TSB-AGCA10 In relation to AgClutch cover 229 2802 CA

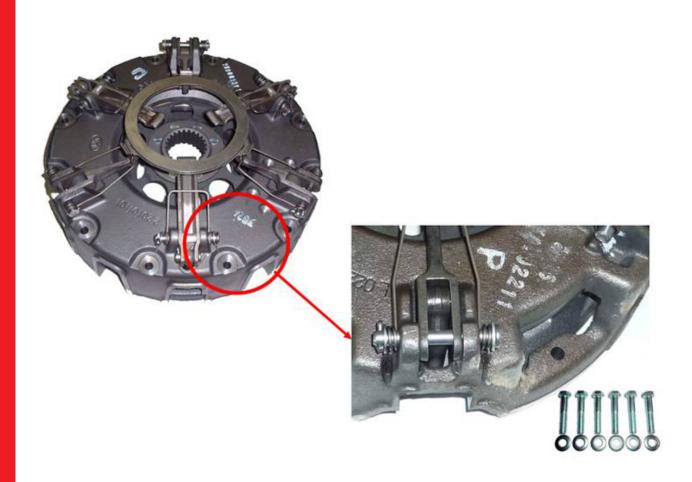
The new clutch cover design uses a vented type housing to improve cooling and heat dispersal. The new design clutch cover is fully interchangable with the existing clutches with no modificationss required to the vehilce or flywheel. New fixing bolt set (6 x M8x1.25x50mm) are supplied with the new cover design to accommodate the lower housing.
